COAST CAR WASH – PRELIMINARY CONDITIONAL USE PERMIT -- PC16-0062

Engineering Department Comments (8/10/16)

**ENGINEERING COMMENTS  
FOR  
PLAN COMMISSION  
AGENDA  
Wednesday  
August 10, 2016  
REVISED**

**PC16-0062** Coast Car Wash, 905 Anitol – Preliminary Conditional Use Permit

**COAST WASH EXPRESS**  
**SITE PLAN**  
**PROPOSED CAR WASH SITE**  
CITY OF WAUKESHA, WAUKESHA COUNTY, WISCONSIN

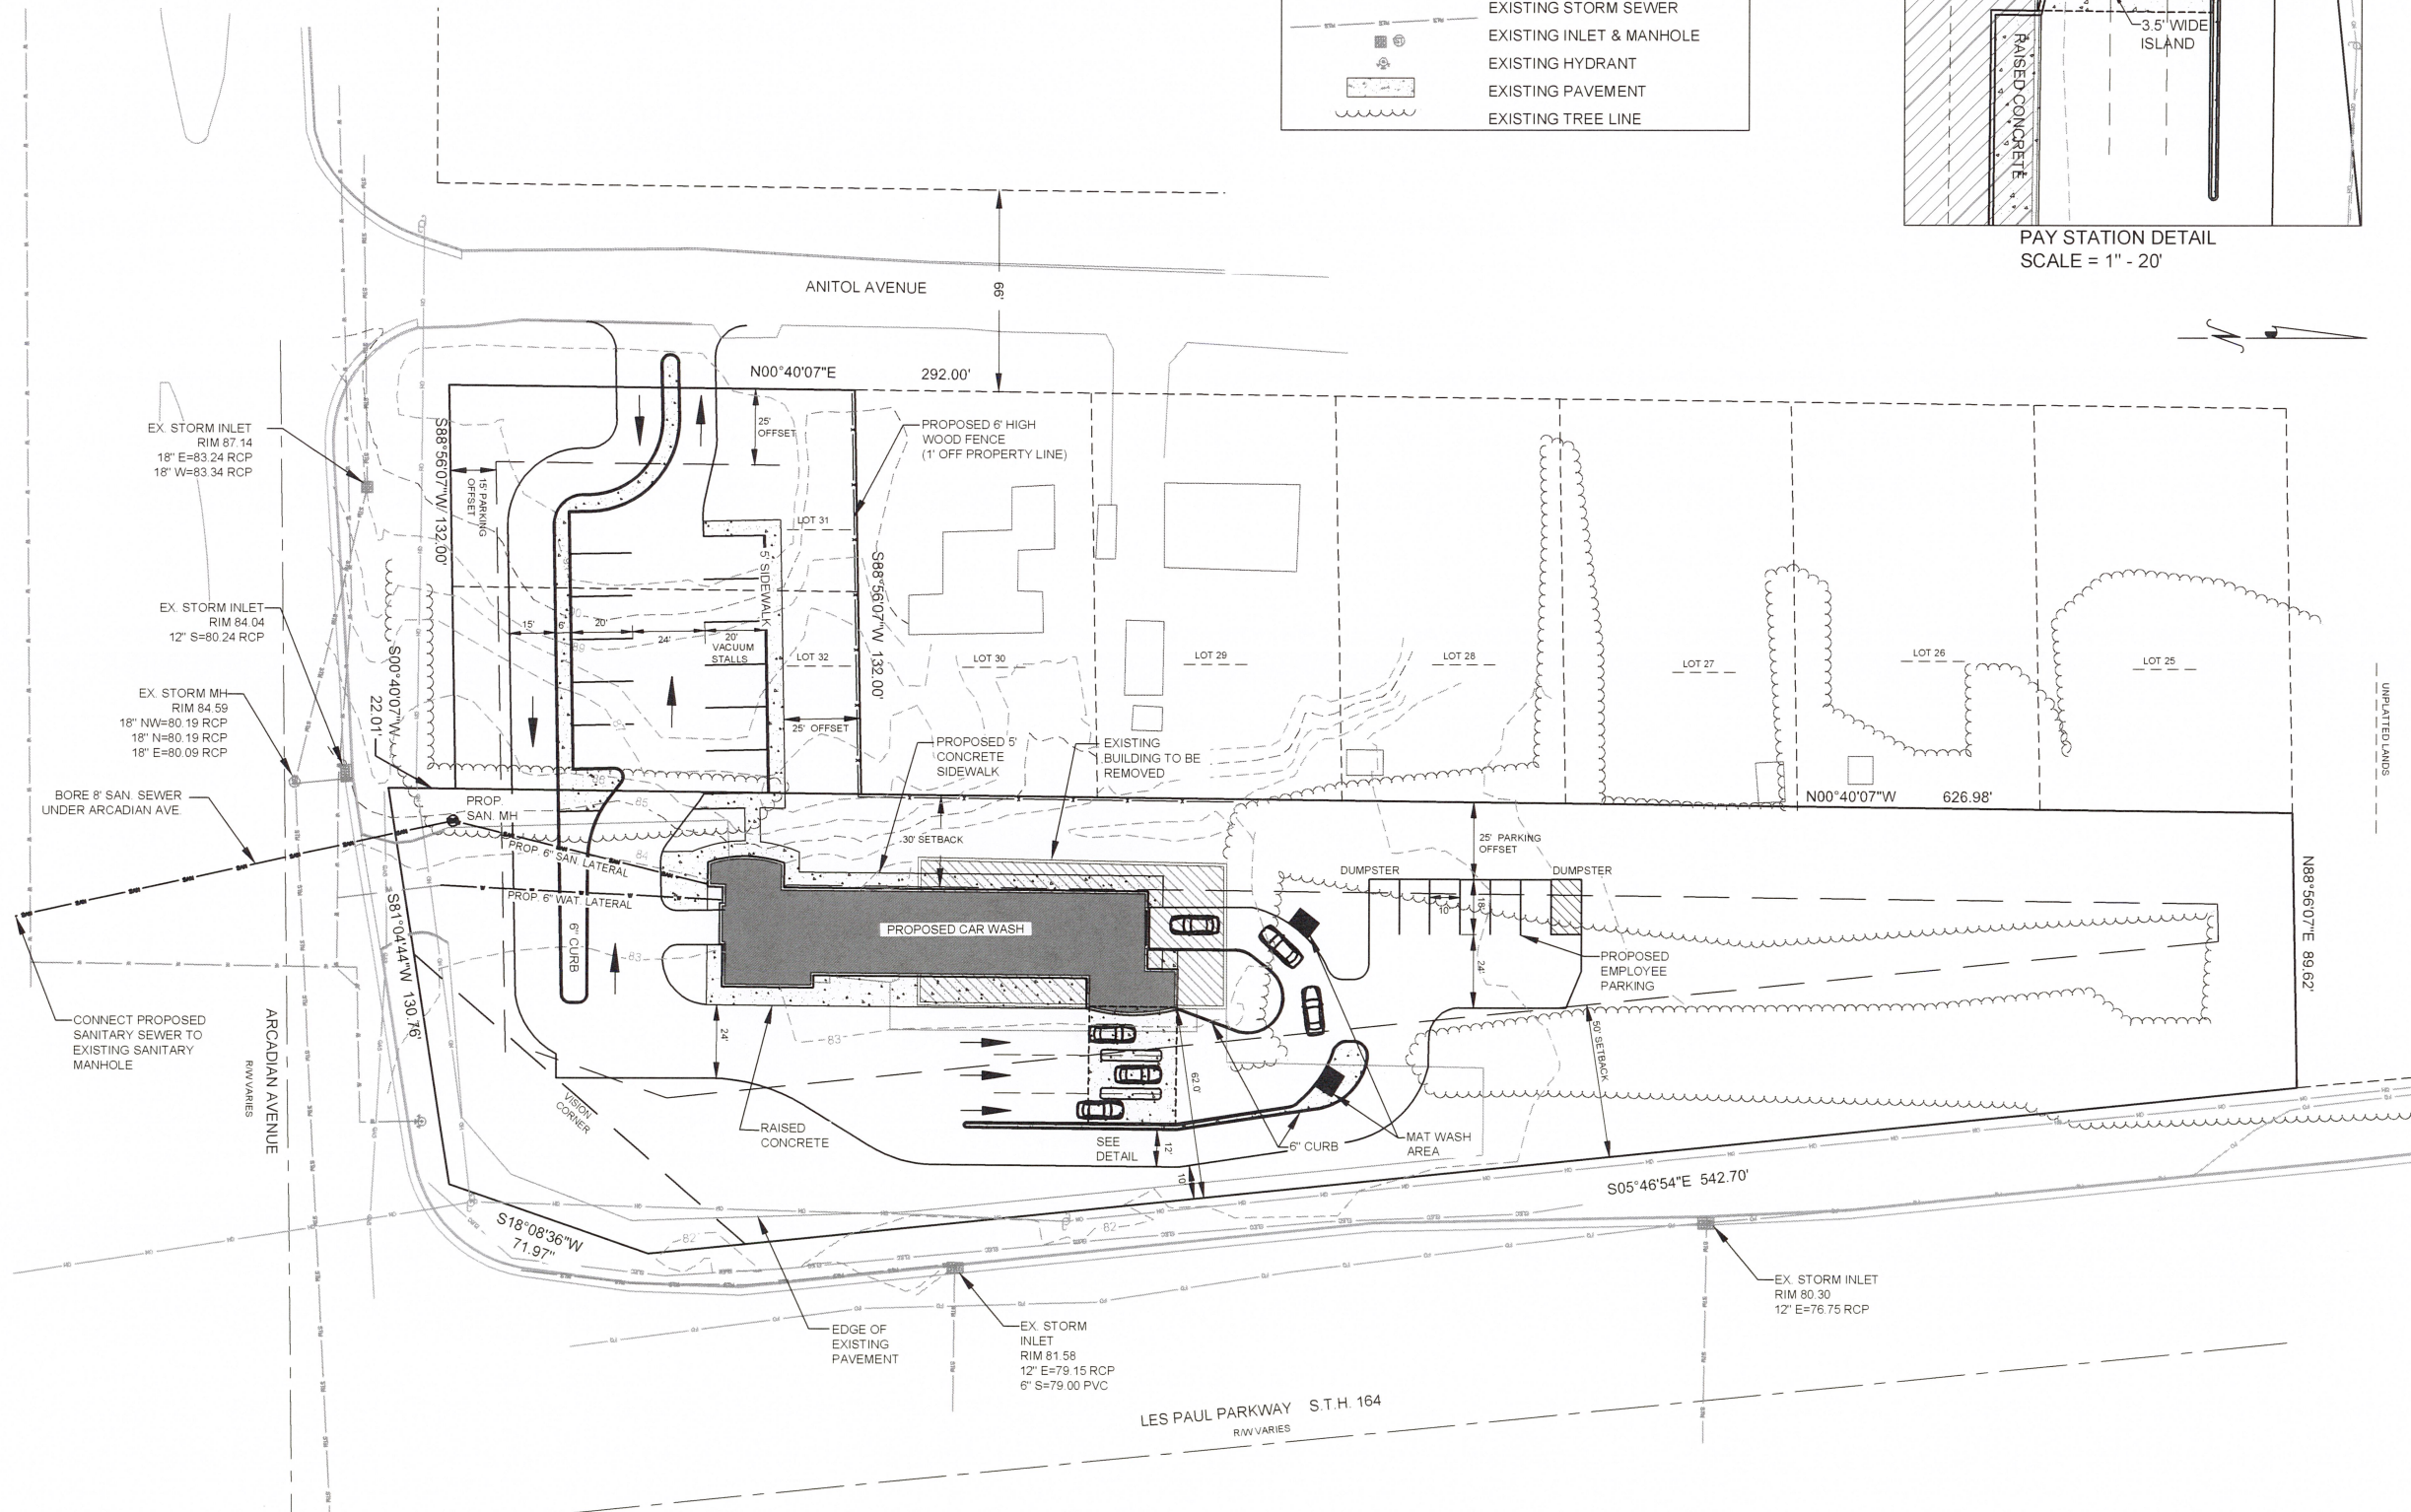
1. In accordance with Wisconsin Administrative Code A-E 2.02(4): Each sheet of plans, drawings, documents, specifications and reports for architectural, landscape architectural, professional engineering, design or land surveying practice should be signed, sealed, and dated by the registrant or permit holder who prepared, or directed and controlled preparation of, the written material.

2. Provide turning movement analysis for fire trucks, delivery trucks through parking lot and drive through.
3. Show existing underground pipes on site and adjoining site, and in public right of ways.

4. Show existing easements.
5. A proposed driveway access is shown from Arcadian Avenue and Anitol Avenue. The Arcadian Avenue access is within the zone of influence of the intersection with Les Paul Parkway (STH 164). The access off of Arcadian Avenue will require Wisconsin DOT approval. The Developer should obtain this approval prior to City site layout approval. A traffic study may be required by the Wisconsin DOT.

- a. Confirm if any existing access limitations are present on this property along Arcadian Avenue.
6. A current title report should be obtained and submitted to the City for both parcels including all restrictions, covenants, and easements of record.

7. More detail is needed to show where the proposed drainage is intended to be directed. Confirm how the site runoff will be collected from conveyed off site. Additional storm sewer measures are needed.

8. It appears that a proposed fence is shown within the vision corner easement. The plan should be revised. Additional fence details should be added to the Drawings.

9. Additional contour labels should be added. Off site runoff should be properly directed around the site.
10. It appears that the building is shown within the building setback. Please confirm.

11. Many more spot grades are needed around the development site to confirm drainage problems are not being created.

12. Existing easements on the site should be shown including source documentation.
13. A note should be added: Repair limits in street will be determined in field at the time of permanent repair.

14. The concrete sidewalk at the apron and the apron should be 7 inch thick concrete sidewalk.
15. Show grades for match point of curb removal and replacement.

16. Show removal limits for whole street from flange to flange. The street will need to be milled and paved.
17. Add Note: Removal limits of repair are approximate and will be determined in the Field by the City.

18. Add City driveway detail. Indicate 7 inch thick concrete.
19. Add City standard curb and gutter detail.
20. Confirm proper ditch grading along Anitol Avenue and culvert sizing, if applicable.

21. Add public sidewalk on Les Paul and Arcadian. Les Paul sidewalk should be 15' from curb.
22. Sidewalk designed at 1.5%
23. Show exist traffic signals

24. Show handicap parking.
25. Widen Anitol Street?
